ADDENDUM NO. 1

FINAL ENVIRONMENTAL IMPACT STATEMENT

Everett Riverfront Redevelopment

**ADDENDUM NO. 1 TO THE EVERETT RIVERFRONT REDEVELOPMENT
FINAL ENVIRONMENTAL IMPACT STATEMENT
November 24, 2008**

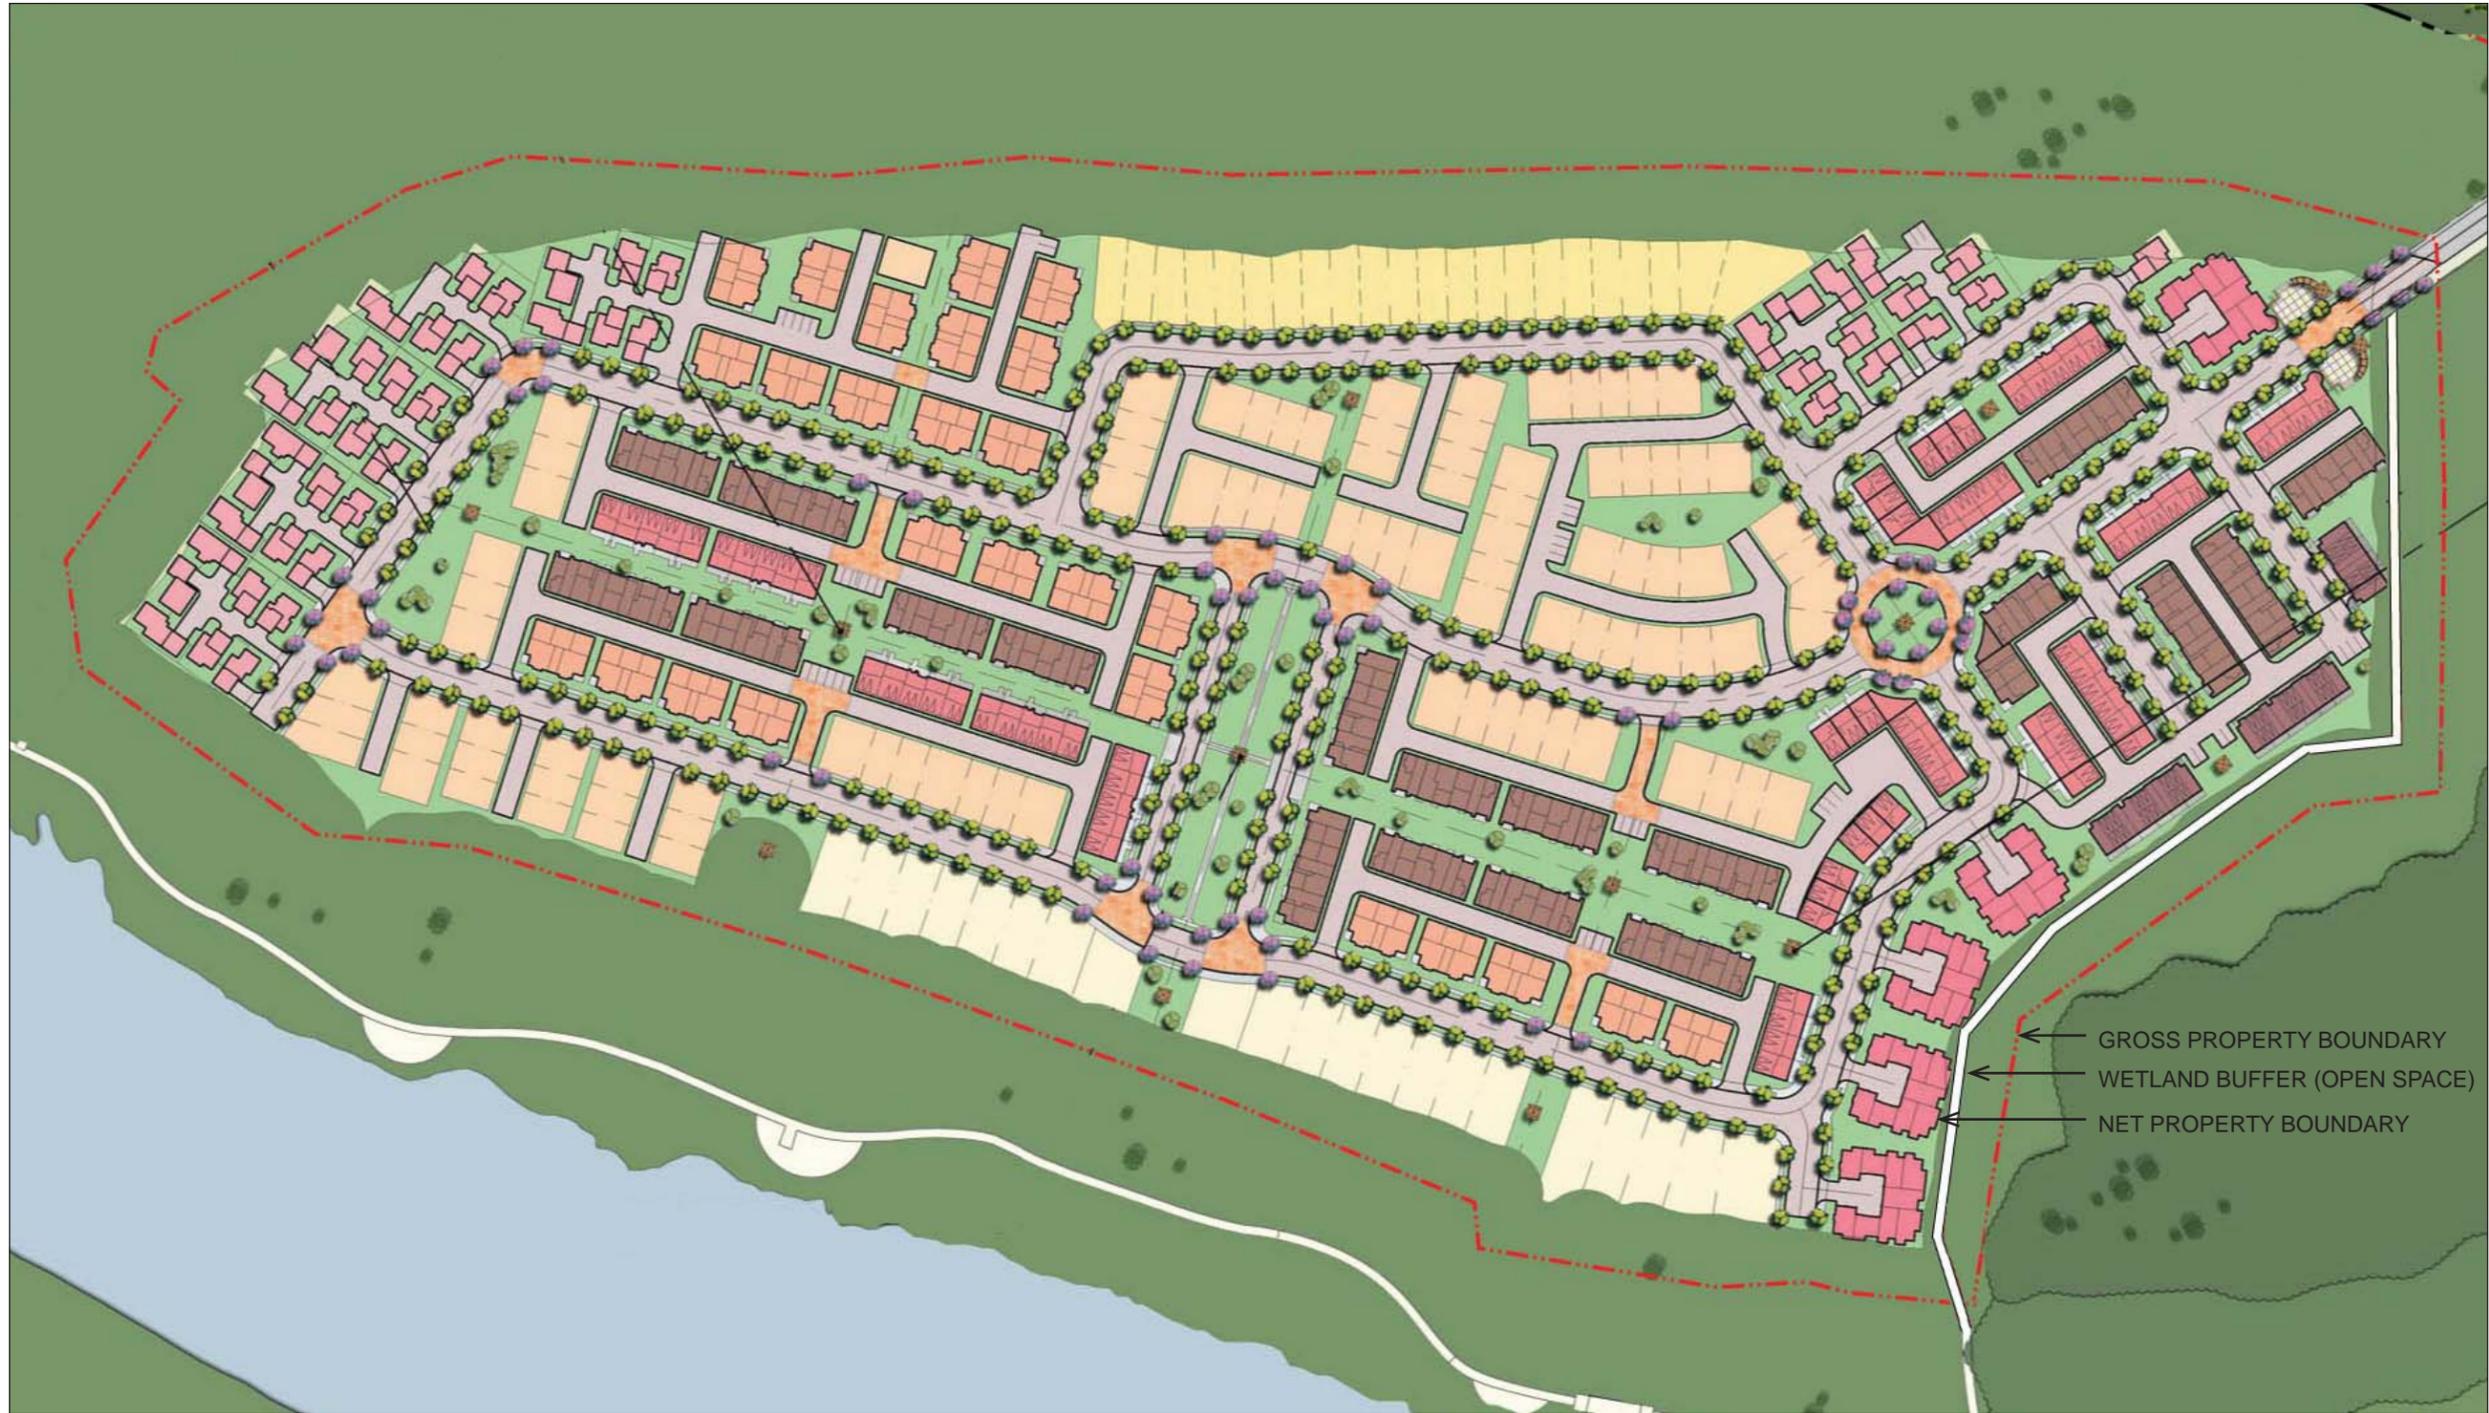
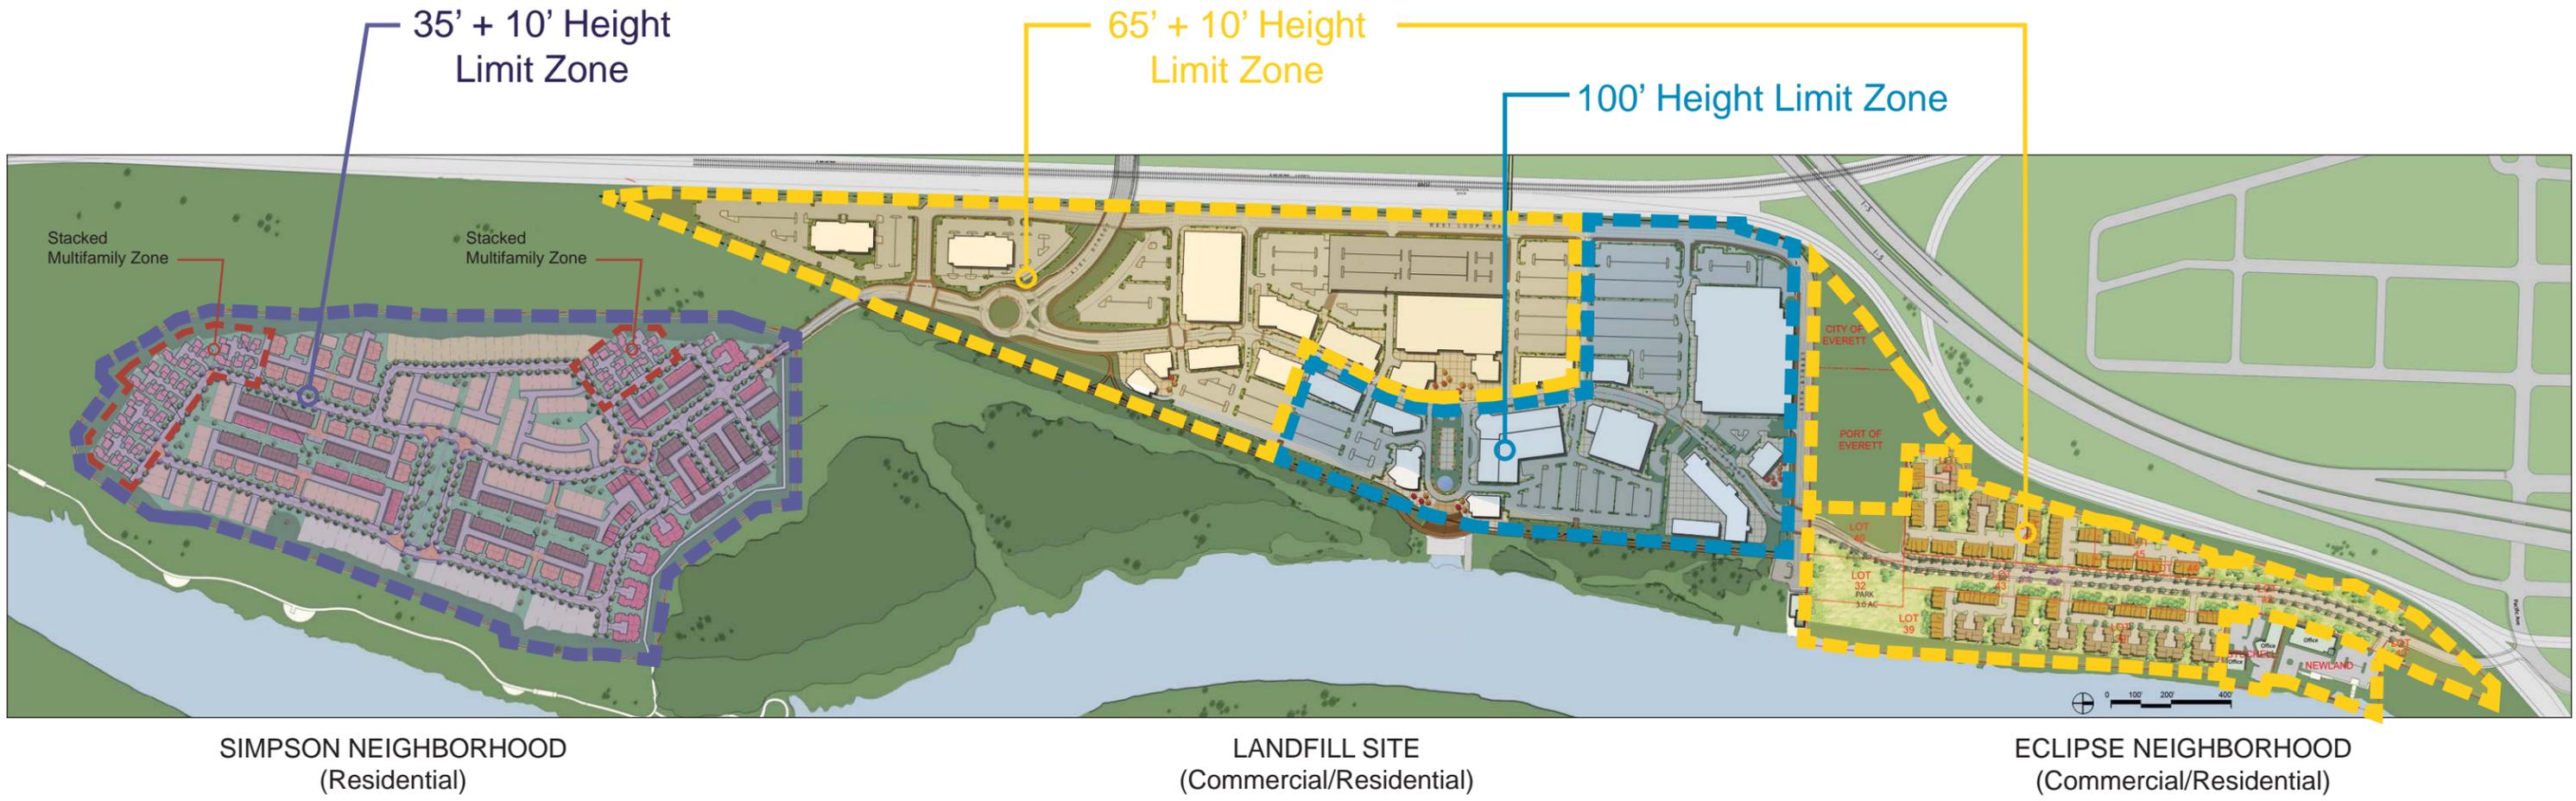
Table 5.1-3 in the Draft EIS was provided to describe the distribution of uses throughout the Project. OM has altered the distribution as illustrated below. There are no changes to the total development area or to the maximum amount of various uses, only changes in the housing types distributed within the project. The changes include an increase in 50 total residential units on the Simpson Pad, increase of 100 residential units on the “Ramp Triangle” (landfill south of 41st), an increase of 50 residential units on the Eclipse Mill site and a reduction of 200 units on the landfill site. All of the changes entail shifting of condominium (multiple family) and townhouses and no changes to single-family detached units.

Figure A1-2

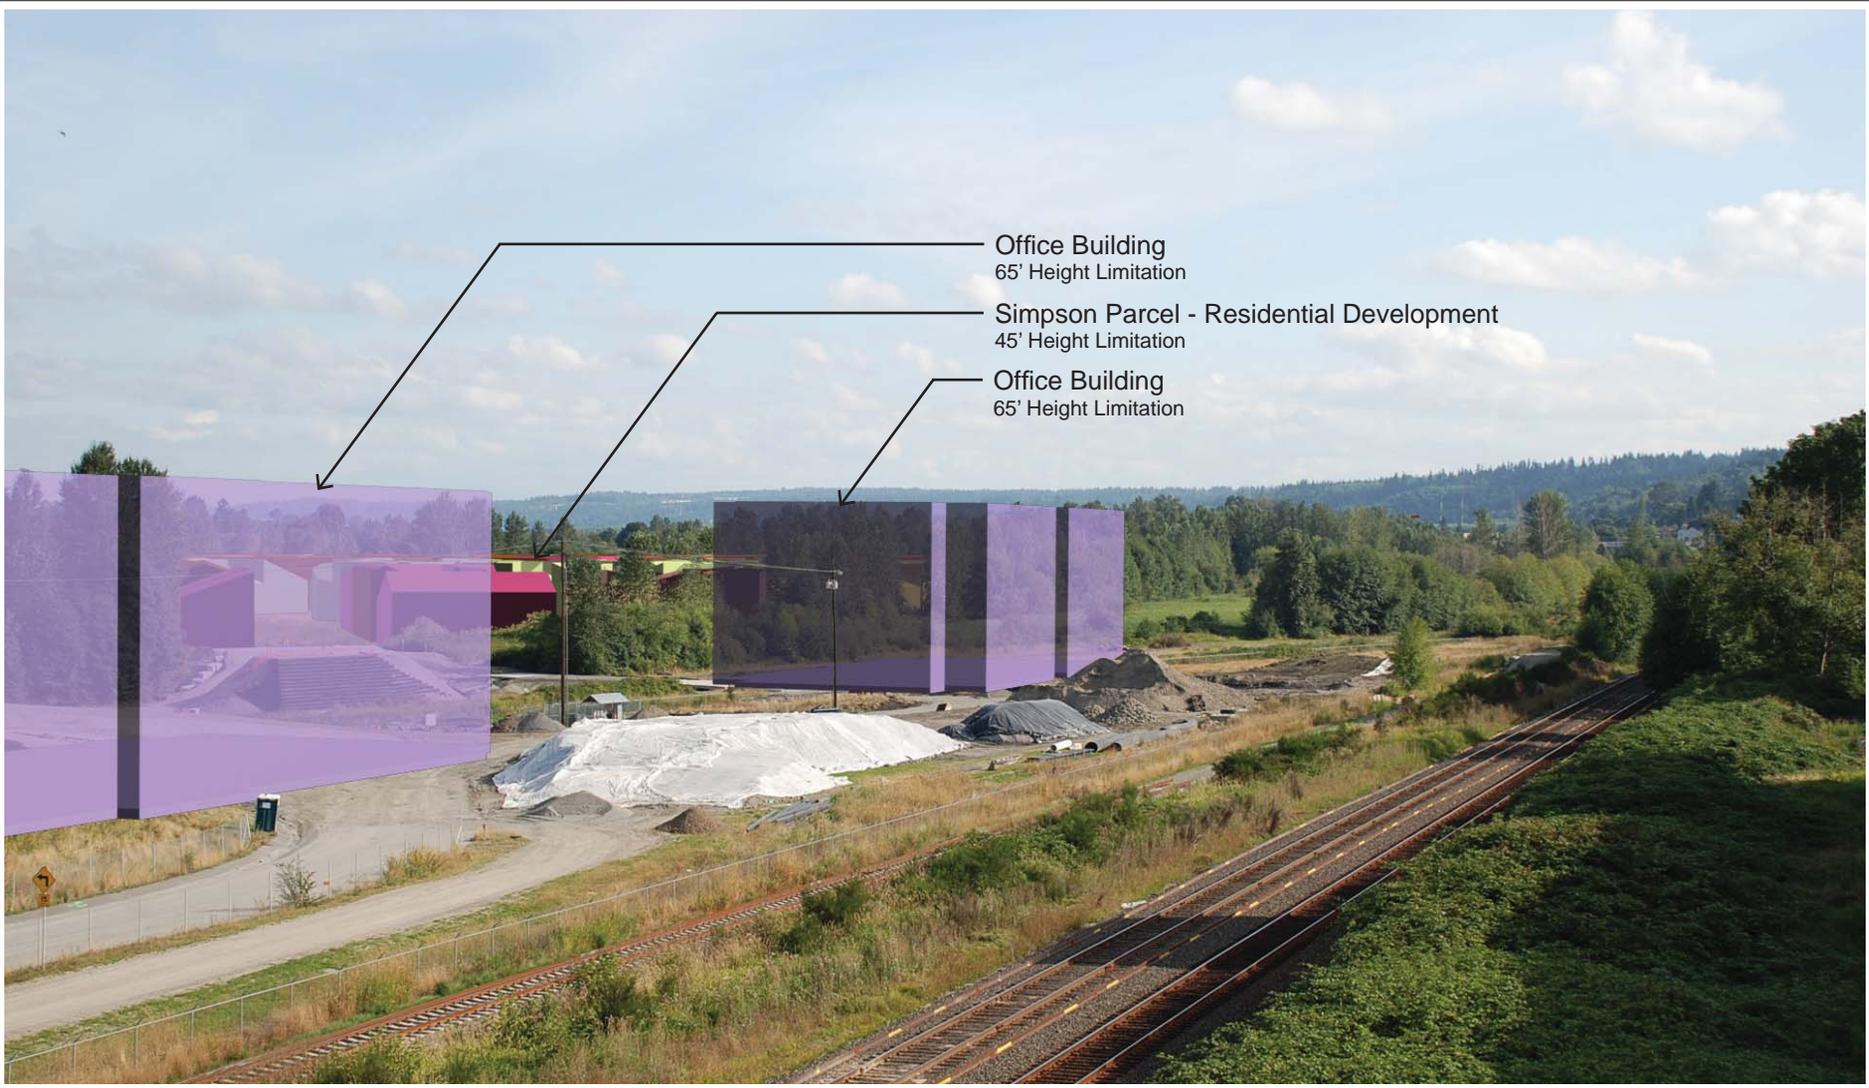
- a) **View 1 Looking south southeast from the top of the 41st Street Overpass above the railroad tracks.** The Draft EIS considered three different view impacts at this location resulting from various Alternatives. The present undeveloped view shows the undeveloped landfill area and Simpson Pad, trees ringing the Simpson Pad and a low hill in the background. There are no views of the Snohomish River or mountains from this location and the vegetation limits any potential vista. The Draft EIS analysis portrayed buildings that would cover and/or block views of the Simpson Pad. The Revised View Analysis shows a similar impact as in the Draft EIS with some minor exceptions. In the Revised View Analysis for View 1 (see Figure A1-3) some trees on the Simpson Pad are obscured from view at their present height. A 15 foot appurtenance, such as mechanical equipment or an elevator penthouse, on these buildings would extend further and potentially block a portion of the view of foothills in the background. The overall impact in this view still provides corridors with trees in the view and no vistas are impacted. The Revised View Analysis from Viewpoint 1 demonstrates there is no significant impact from the proposed changes in maximum heights on the South landfill/tire fire parcel and Simpson Pad.

Figure A1-7

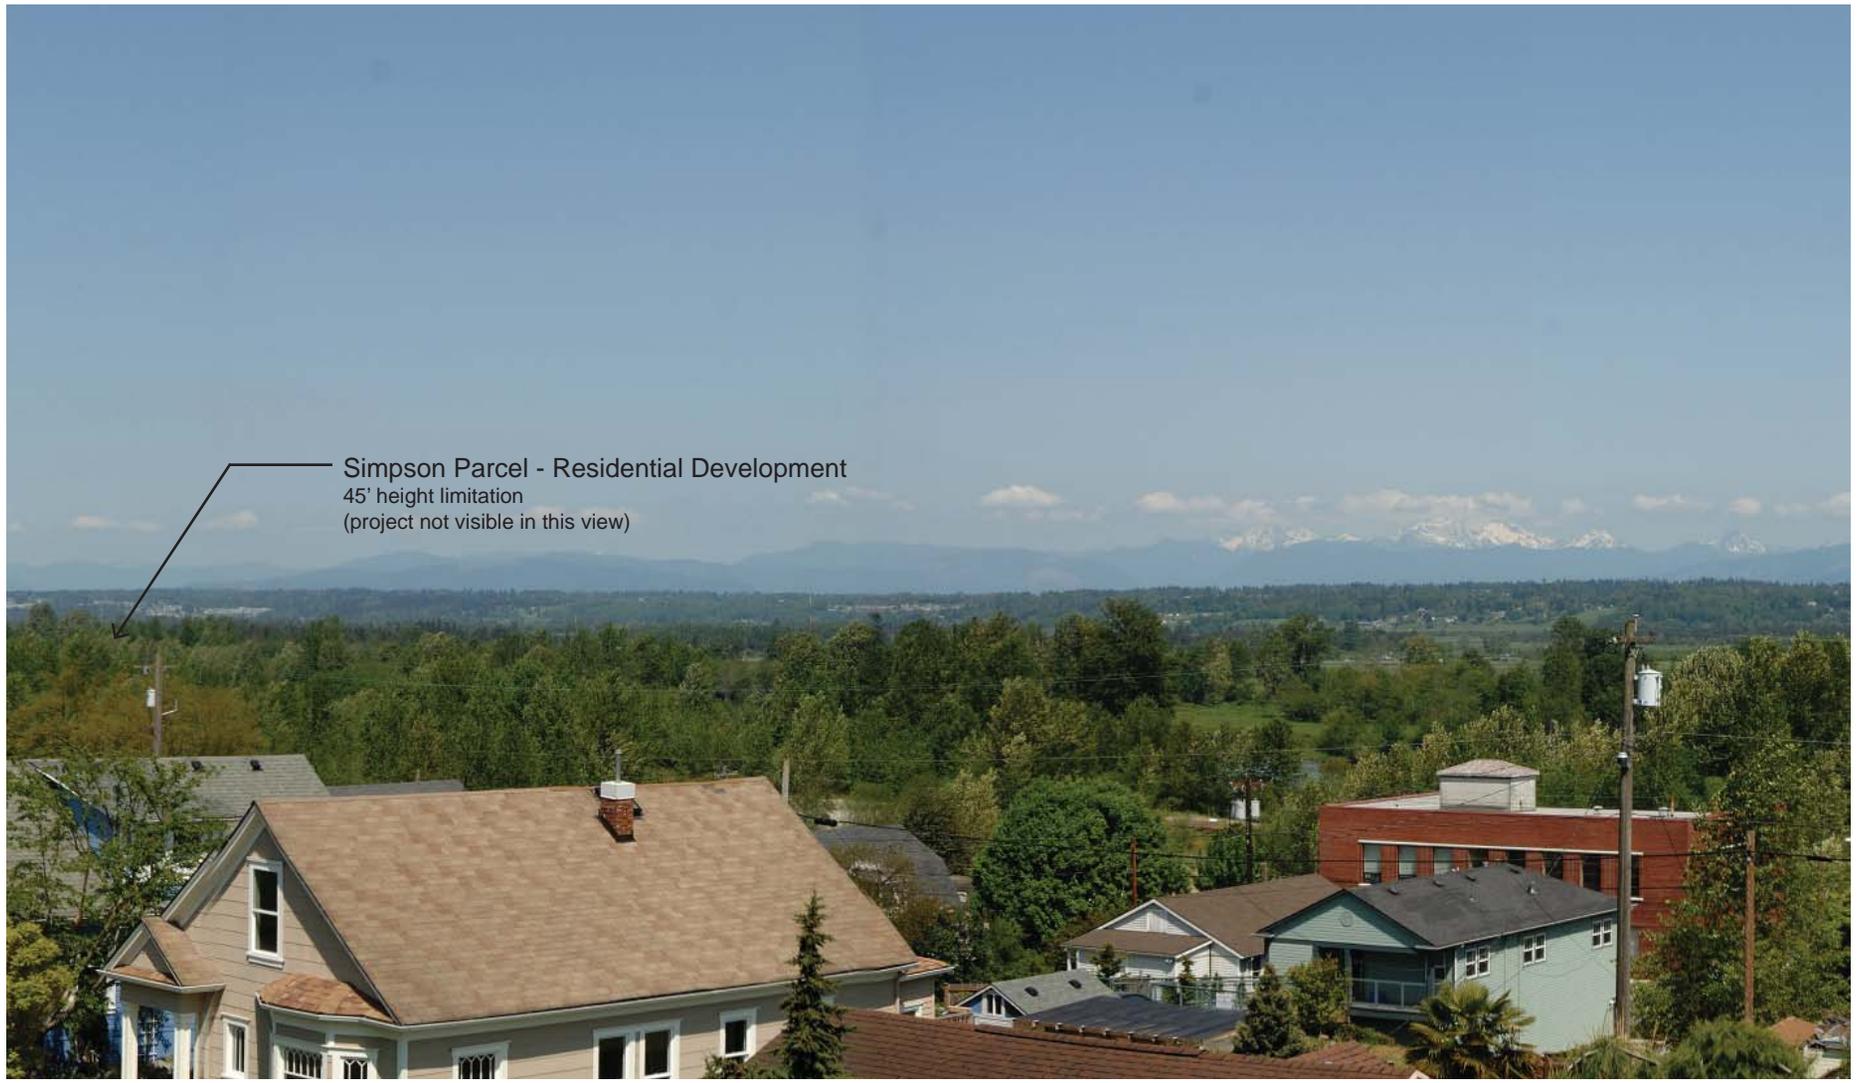
- view by trees and other vegetation that lie west of the river. The Revised View Analysis at this location (see A1-7) shows the development on the Simpson Pad is visible but it does not obscure any portions of the existing vista. Only the presently undeveloped Simpson Pad and some of the trees east of the Pad are covered by the project development. Views of the valley, foothills and mountains, etc are unimpeded. The Revised View Analysis from Viewpoint 3 demonstrates there is no significant impact from the proposed change in maximum height on the Simpson Pad.
